BENT GRASS EAST COMMERCIAL FILING 3

PRELIMINARY PLAN

PCD#: SP-20-010

Prelim plan V_3 comment planning only.pdf Markup Summary

COVER SHEET

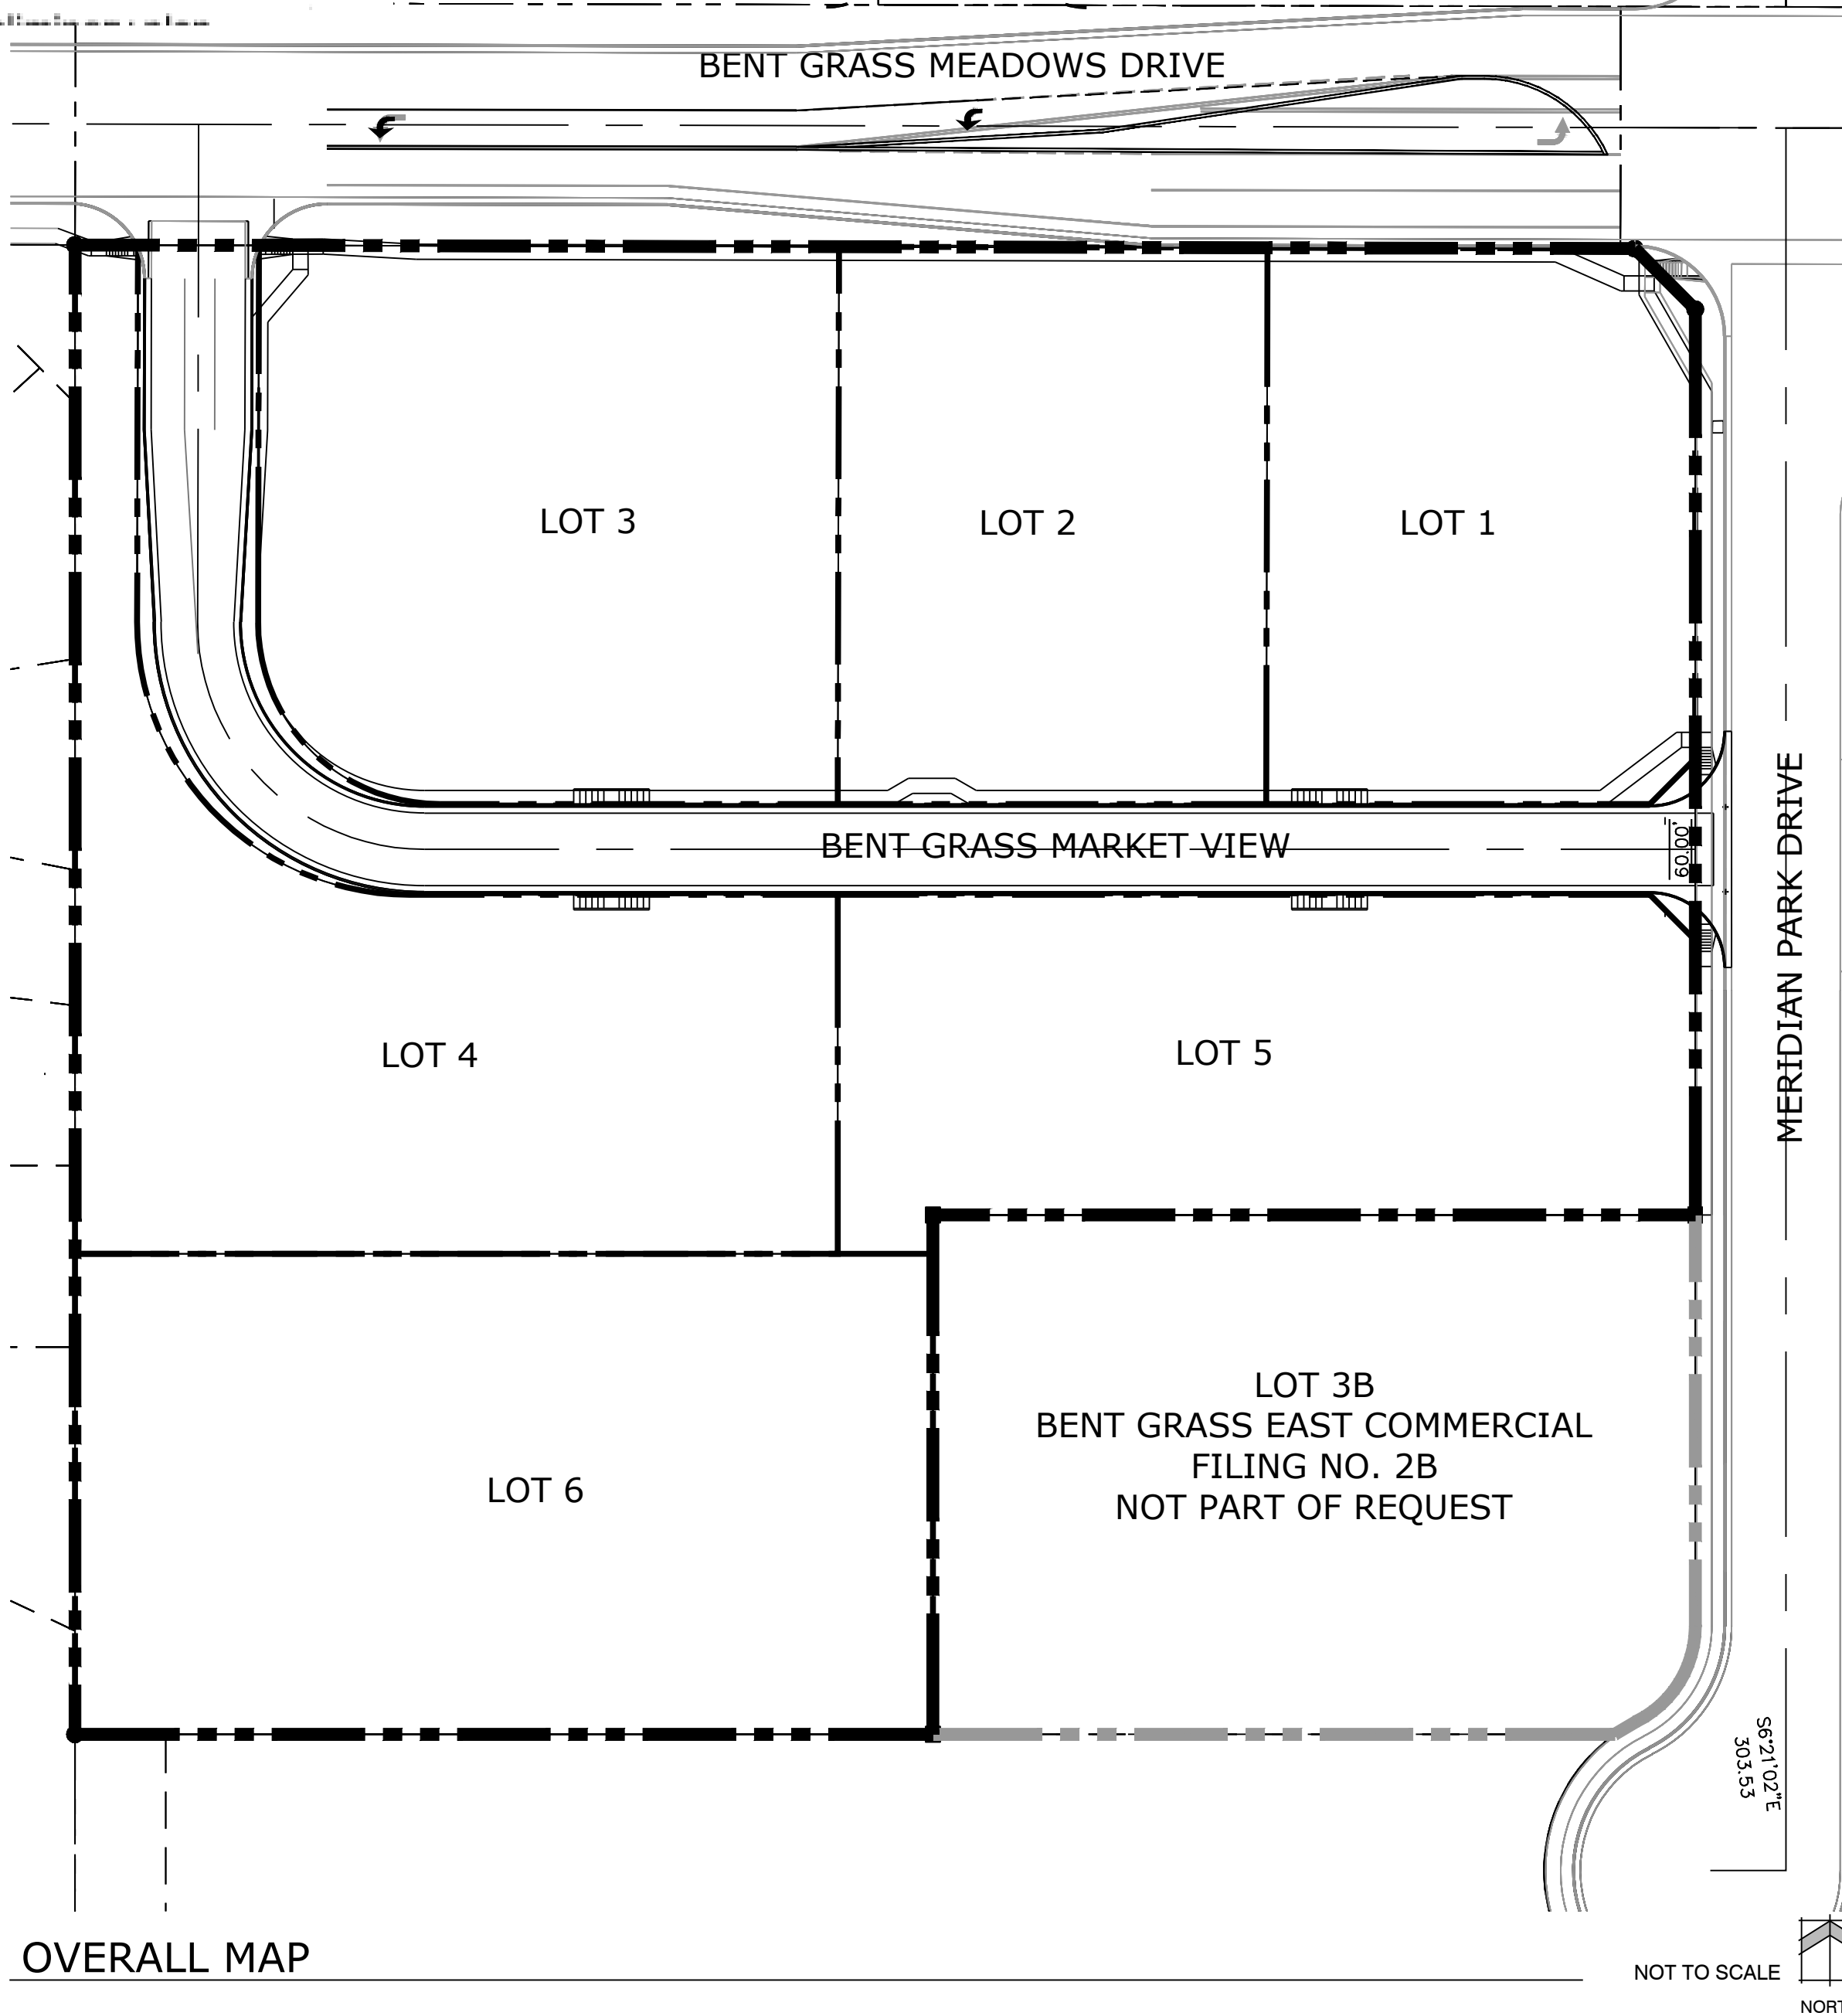
correct legal to include requirement on old checklist

Legal includes approximate survey tie to an accepted survey monument?

PRELIMINARY PLAN

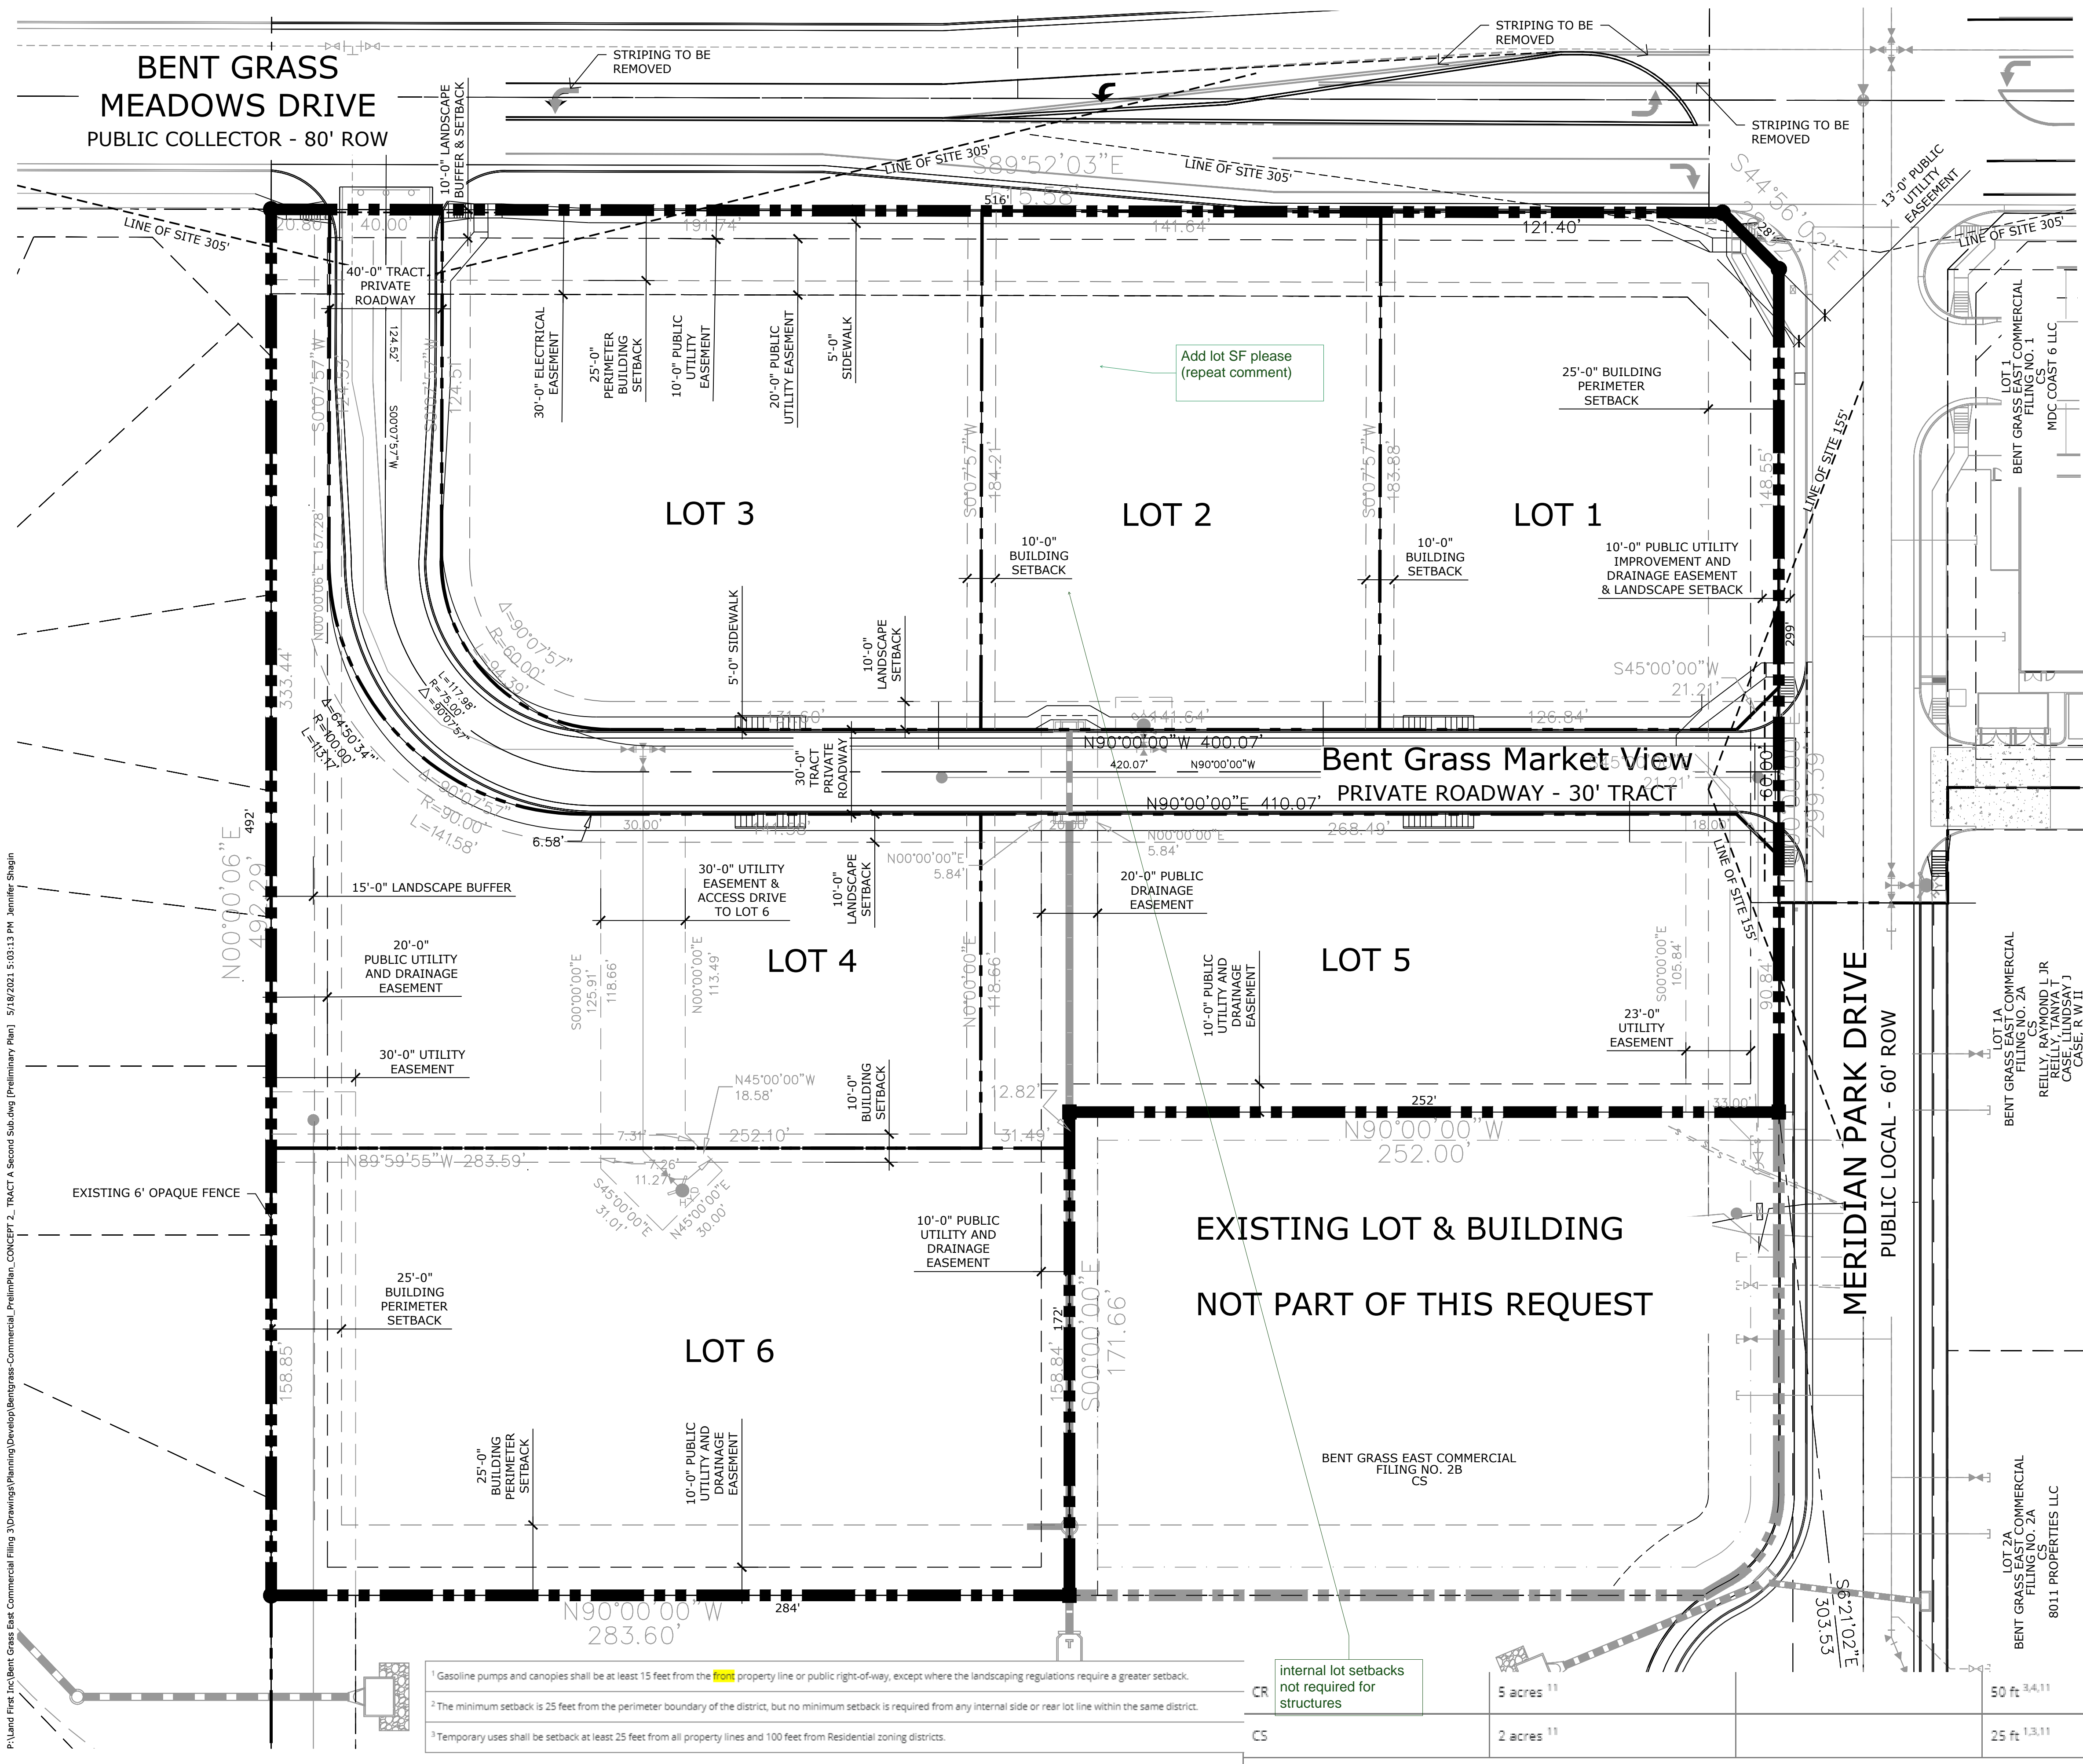
internal lot setbacks not required for structures

LANDSCAPE NOTES AND DETAILS

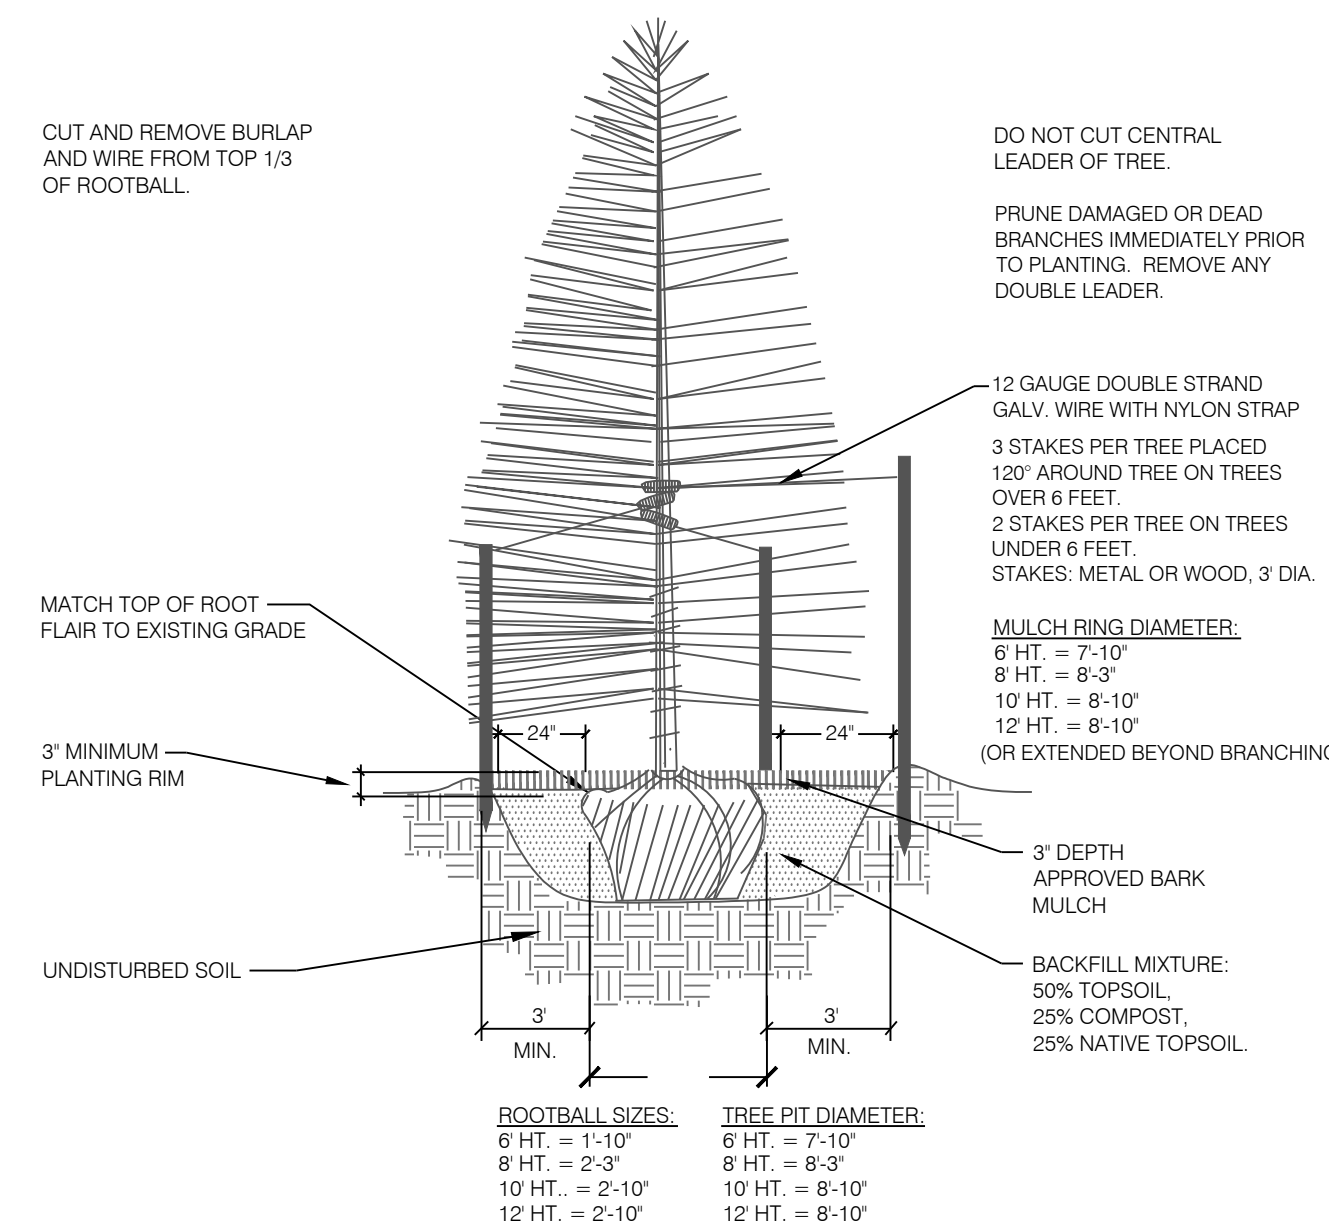
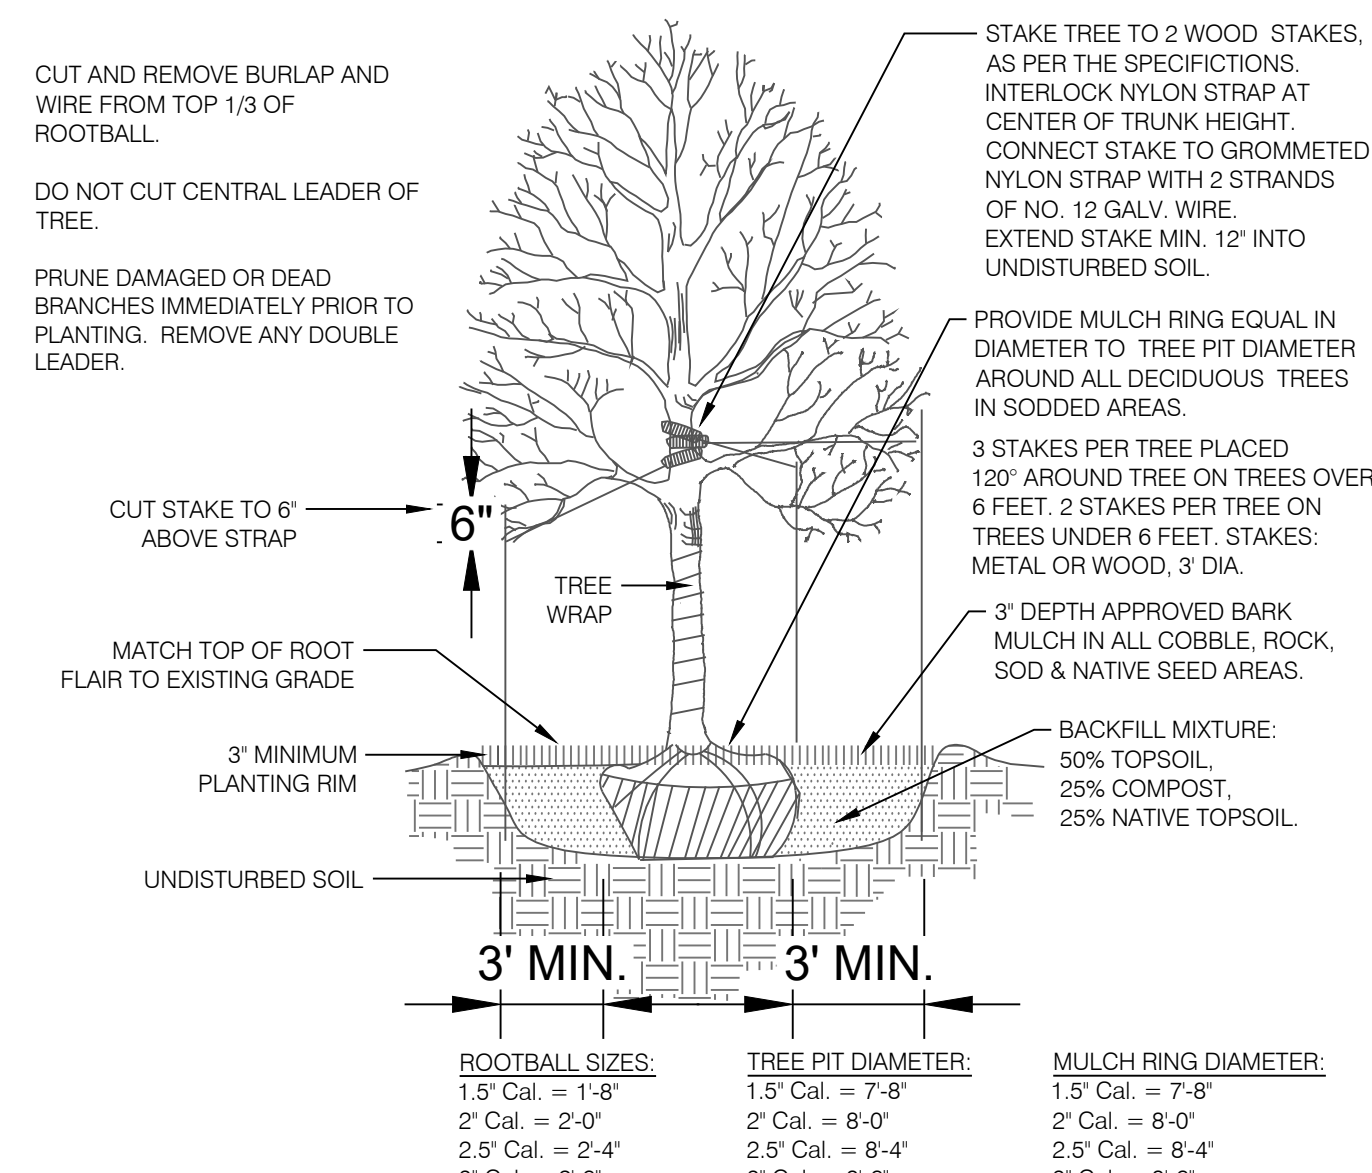
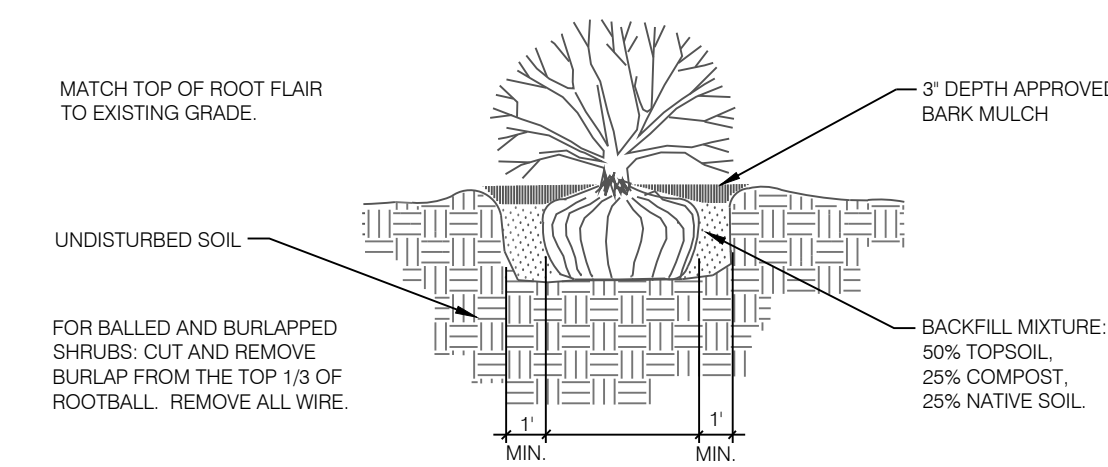
EVERGREEN TREE REQUIRED / Please show calculations for required for roadway and buffer

the commercial is responsible for the wall not the residential. Have you obtained a letter from the individual property owners that they agree to maintain the existing fence not wall on? Do they support a waiver of the opaque wall being installed and maintained by individual lot owners not commercial to support the waiver of the requirement for the commercial to provide the wall?

there is no requirement for the lot owners to have a fence; it is on the commercial. Maybe the commercial would like provide a maintenance agreement for fencing or replace the fence w concrete or CMU block? Staff will likely note the issue in the staff report

provide the commercial wall as required.
